MEMORANDUM

To: El Paso County PCD File #: PPR-2315

Date: September 11, 2023 Project No.: 24-0409.00

Re: Super Star Car Wash (Claremont Business Park 2) Traffic Compliance Letter

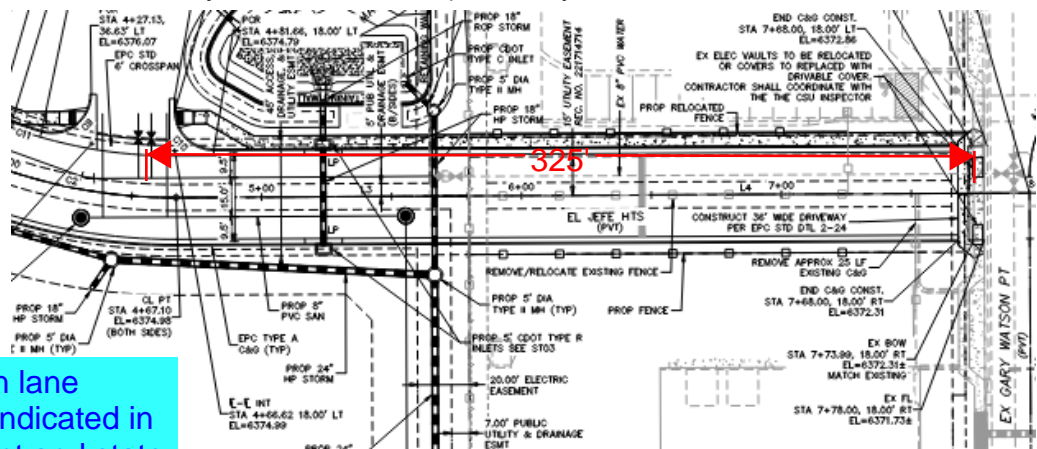
south

please state whether this sight distance is met. It appears there is approx. 325' to the intersection of el jefe heights and Gary Watson Point.

Please provide Aux. turn lane analysis for this site as indicated in previous review comment and state whether a turn lane from El Jefe Heights into the driveway is needed/recommended.
